DOCKETED	
Docket Number:	23-AFC-01
Project Title:	Morton Bay Geothermal Project (MBGP)
TN #:	258975
Document Title:	Morton Bay Geothermal LLC Comments on the Preliminary Staff Assessment
Description:	N/A
Filer:	Jerry Salamy
Organization:	Jacobs
Submitter Role:	Applicant Consultant
Submission Date:	9/4/2024 3:38:22 PM
Docketed Date:	9/4/2024

Morton Bay Geothermal Project (23-AFC-01) Preliminary Staff Assessment Comments

Prepared by
Morton Bay Geothermal LLC

Figure 5.2-1R
Land Cover and Vegetation Types
Morton Bay Geothermal Project
Imperial County, California

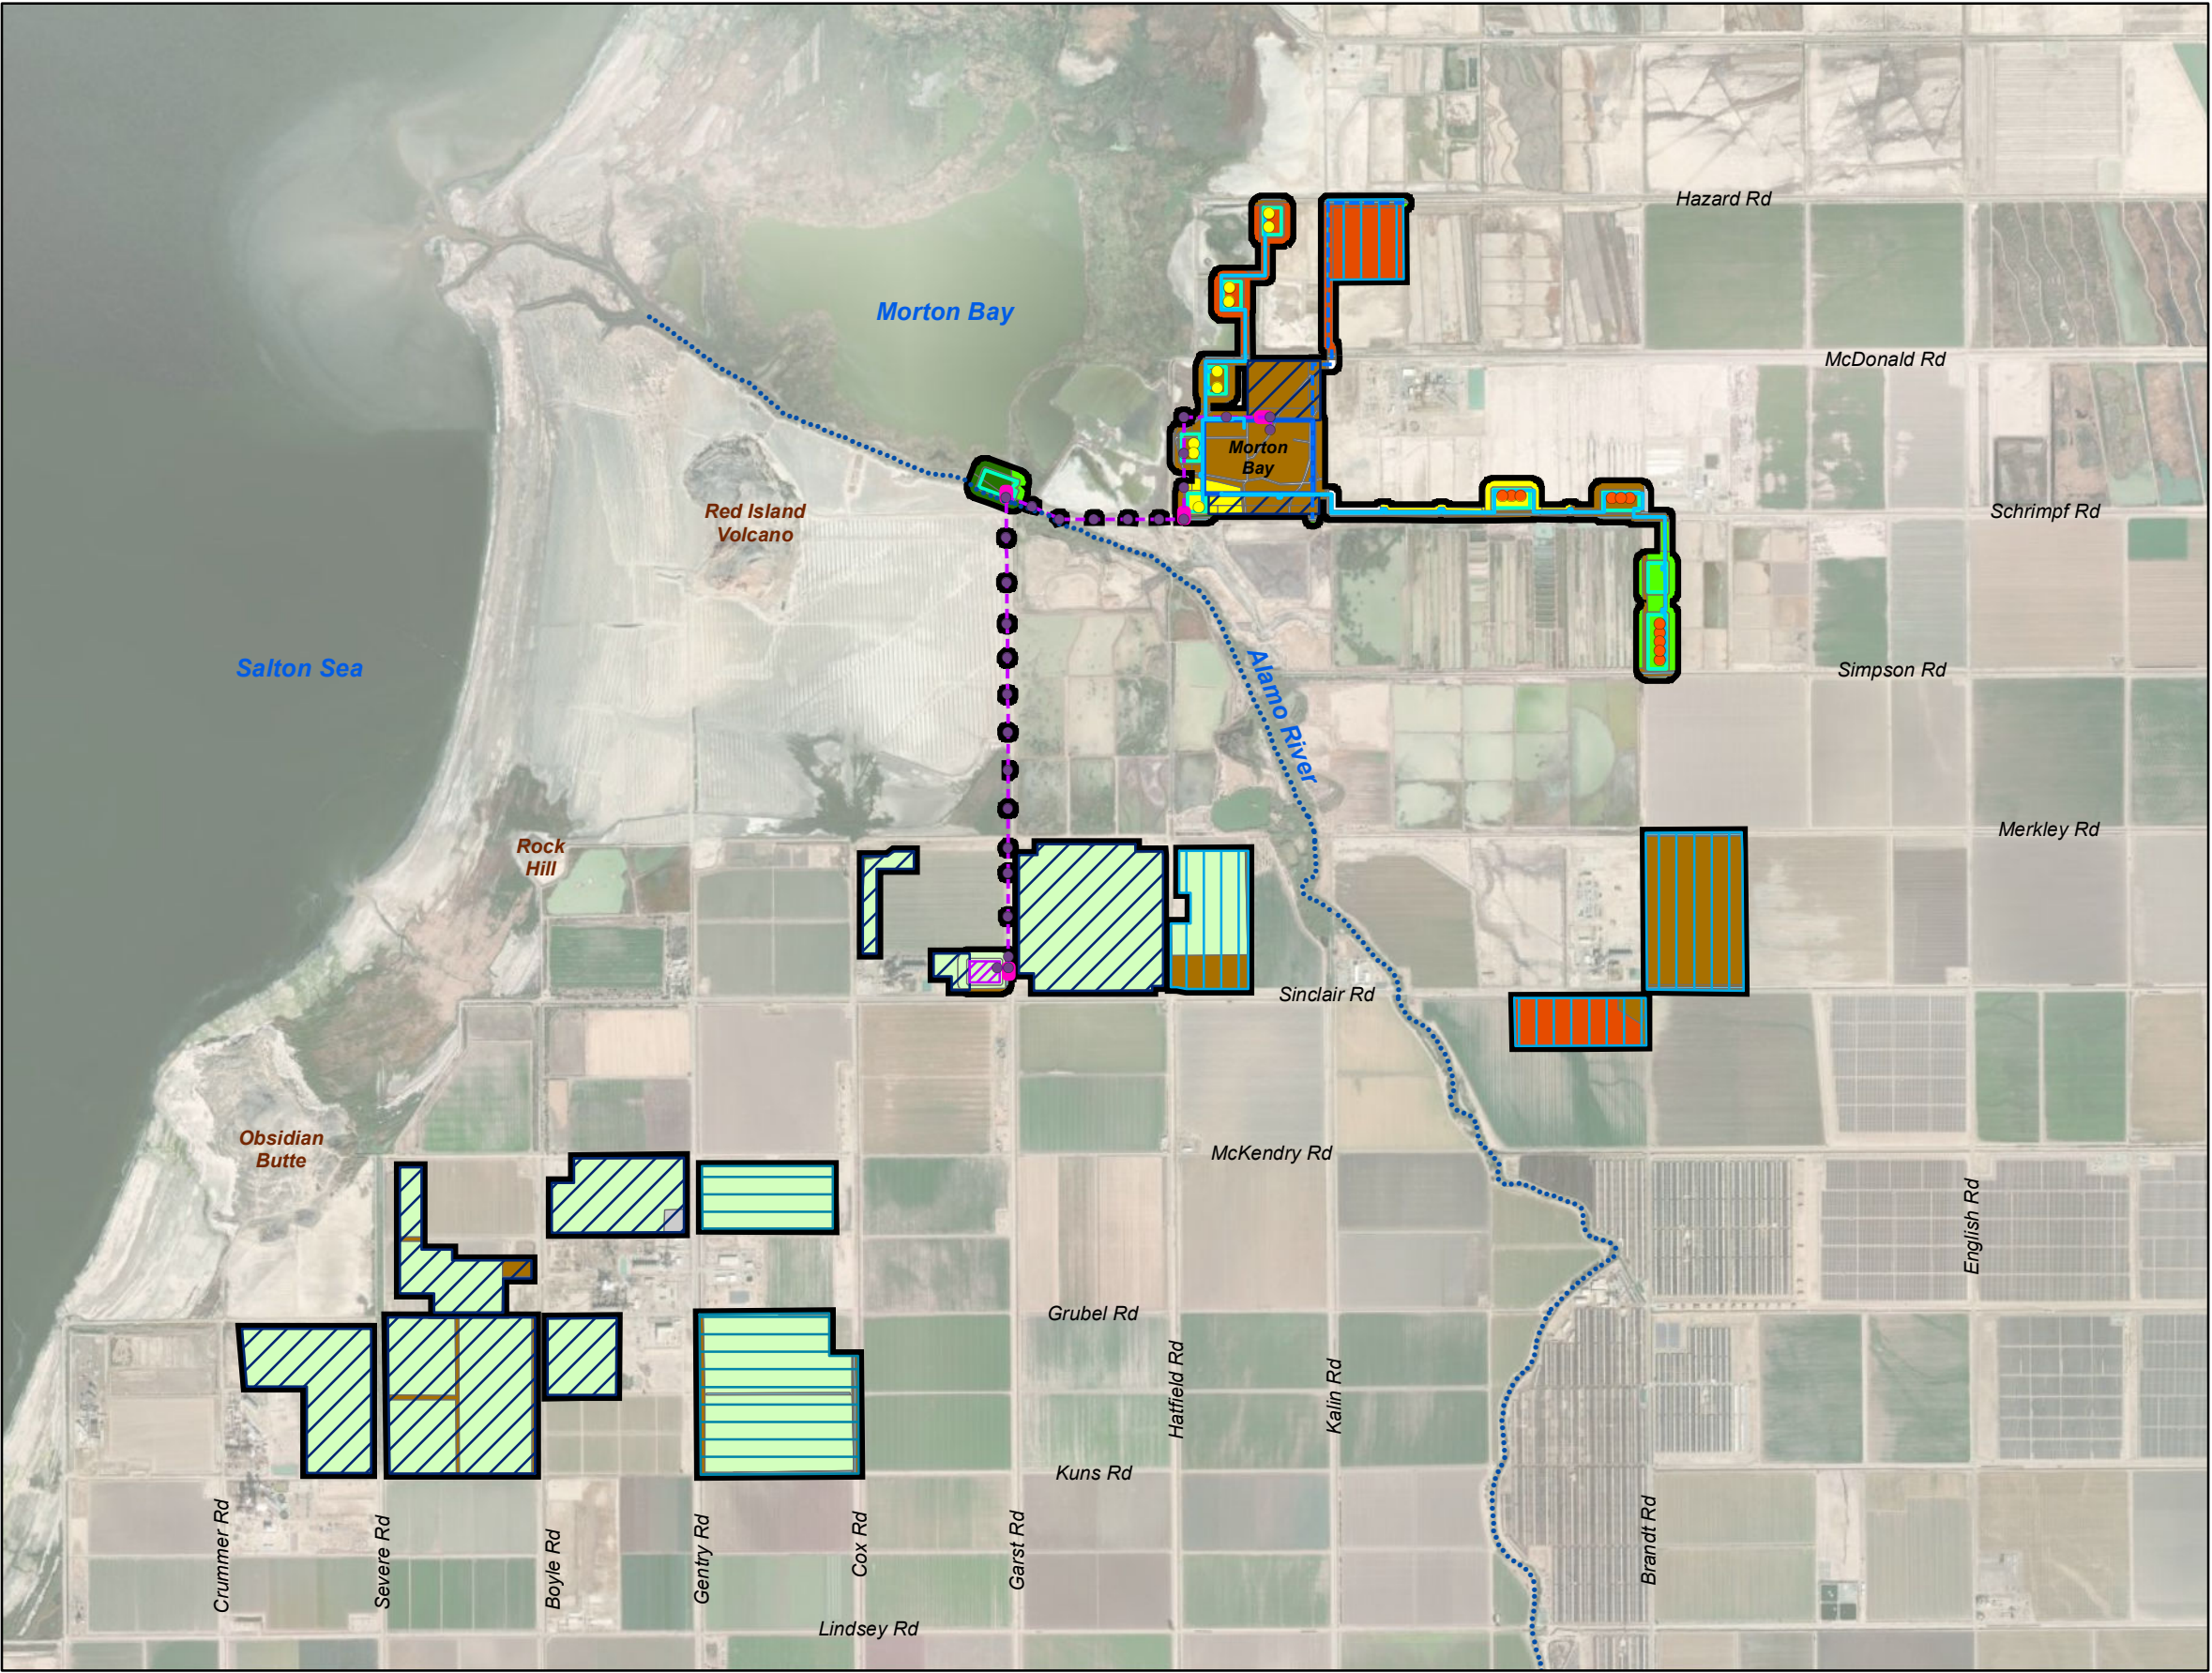
Pages 5.2-126 through 5.2-127, Table 5.2-5 Temporary and Permanent Impacts to Vegetation Communities and Other Land Cover Types Within the Project Biological Study Area Based on Applicant GIS and Associated Buffer Areas. Revised Table 5.2-5 reflects current vegetation and land cover impacts of the project while removing overlapping features.
